**City of Portland, Maine – Building or Use Permit Application** 389 Congress Street, 04101, Tel: (207) 874-8703, FAX: 874-8716

Location of Construction: 537 Washington Ave 04102		Owner: * Richard Waltz		Phone: 774-2234		Permit No:	
Owner Address: 537 Washington Ave.		Lessee/Buyer's Name:		Phone:		BusinessName:	
Contractor Name: Ernest Dobson		Address:		Phone: 797-2722		Permit Issued: DEC 3 1999	
Past Use: Vacant/ Single Family		Proposed Use: Detached Garage		COST OF WORK: \$ 10,000.00		PERMIT FEE: \$ 84.00	
				FIRE DEPT. <input type="checkbox"/> Approved <input type="checkbox"/> Denied		INSPECTION: Use Group: 4 Type: 5B BOC 12-96	
Proposed Project Description: Construct Detached Garage				Signature:		Signature: <i>Hoffman</i>	
				PEDESTRIAN ACTIVITIES DISTRICT (P.A.D.)		Zone: CBL: 428-C-3	
				Action: Approved <input type="checkbox"/> Approved with Conditions: <input type="checkbox"/> Denied: <input type="checkbox"/>		Zoning Approval: Special Zone or Reviews: <input type="checkbox"/> Shoreland <input type="checkbox"/> Wetland <input type="checkbox"/> Flood Zone <input type="checkbox"/> Subdivision <input type="checkbox"/> Site Plan maj <input type="checkbox"/> minor <input type

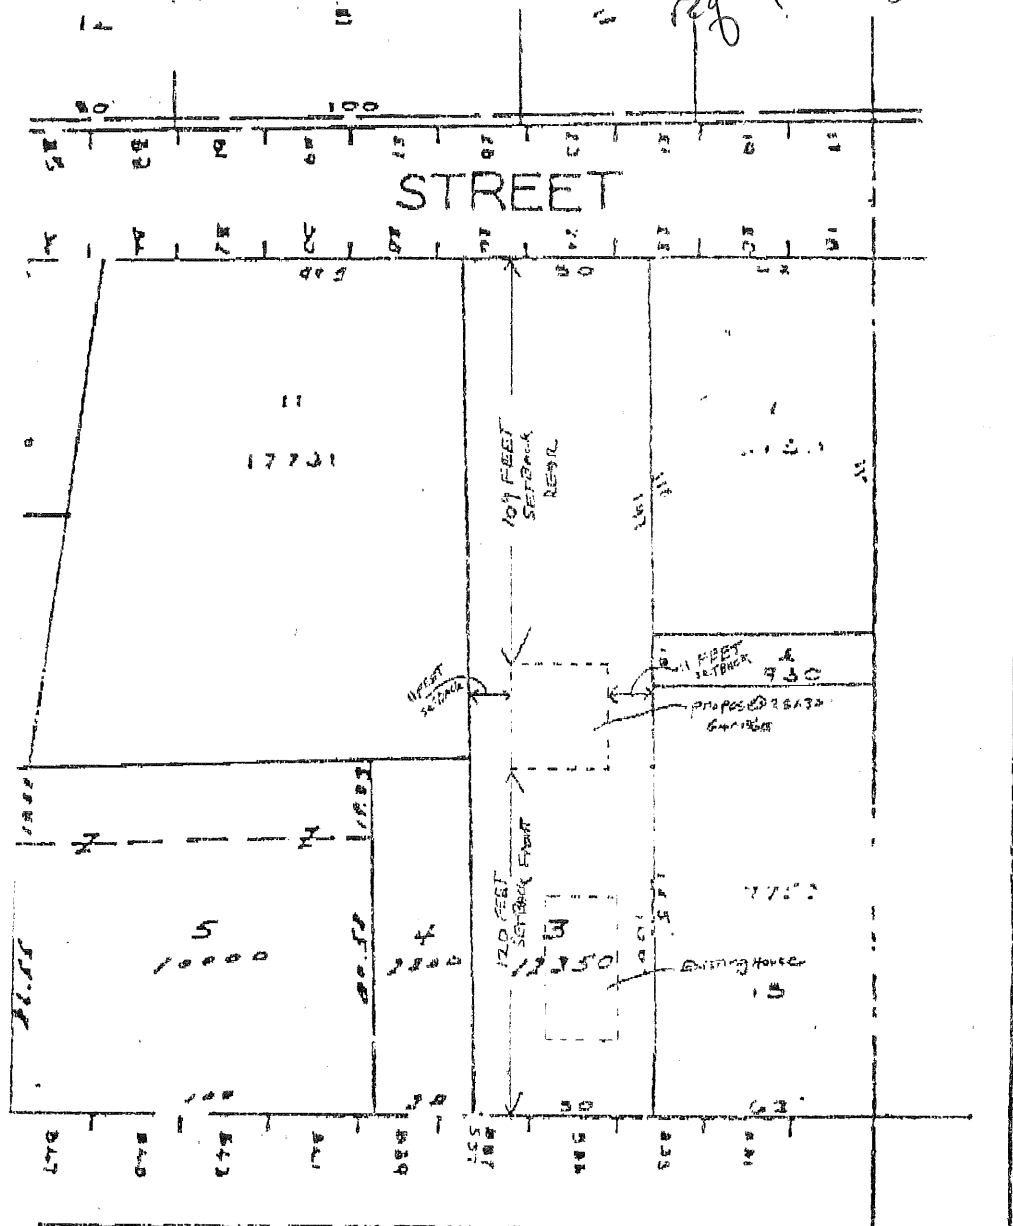
Revised plot plan  
 received 12/3/99  
 R-5

Req. side yard 8' - 11' shown on both sides  
 Req. rear yard 20' - 109' shown  
 Req. front yard 20' - 120' shown

Job ST67545	Truss 528	Truss Type FINK	Qty 300	Ply 1	WSI Stock Trusses 1/1/99 11/3/99	Sheet 37
----------------	--------------	--------------------	------------	----------	-------------------------------------	----------

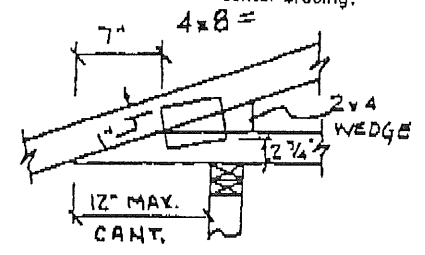
- \*38. Roof Trusses design shall be done in accordance with sections 107.7 and 114.0. - Please submit the design data for the proposed roof trusses

*28' 5/12 Roof Trusses*

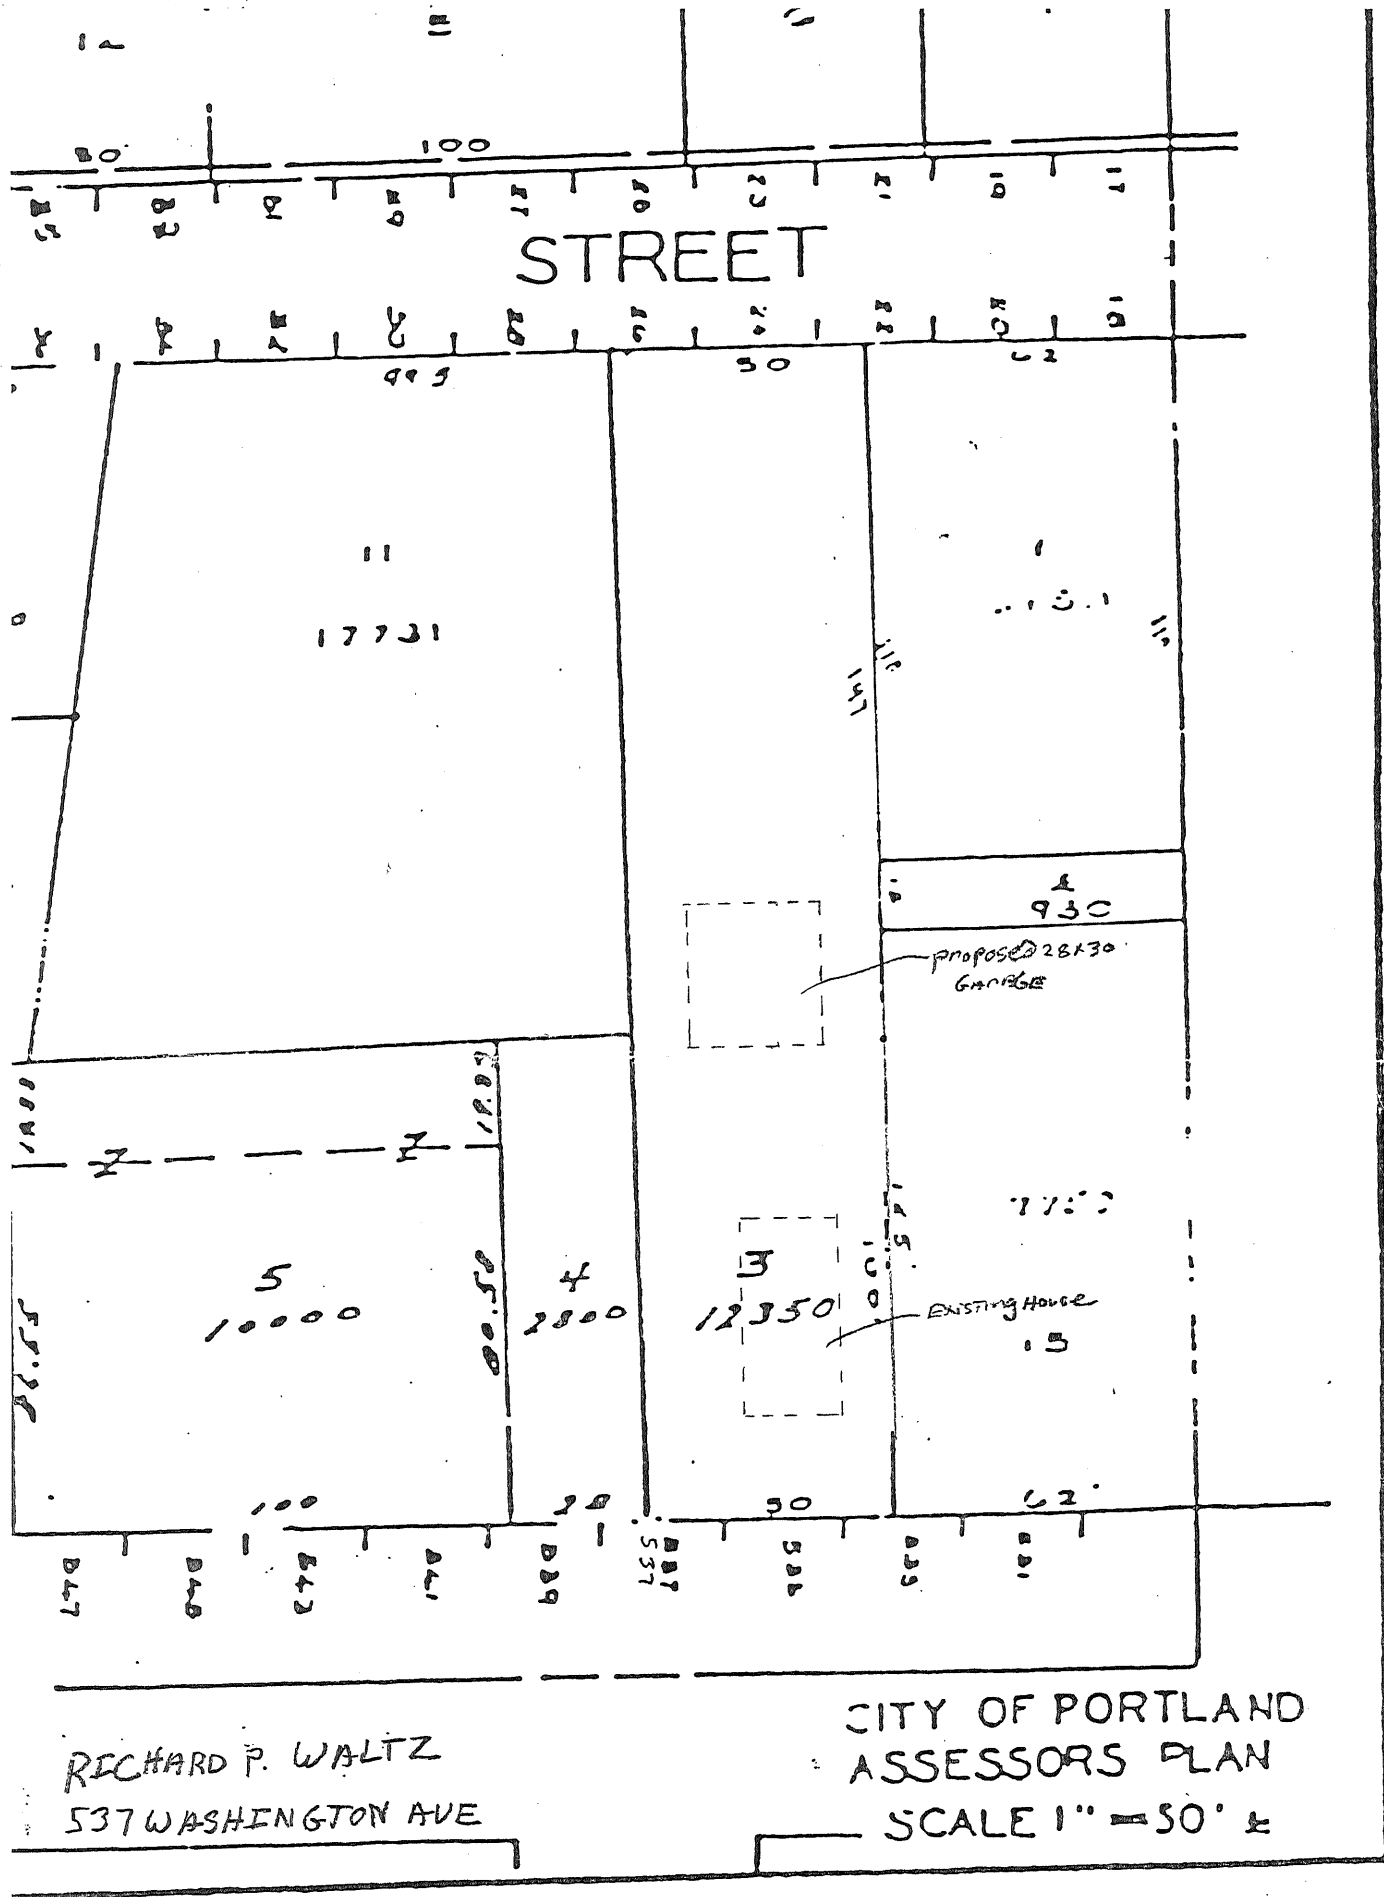
12/1/99  
There are ~~NO~~  
Setback dimensions  
on this & it is  
not to a 50' scale
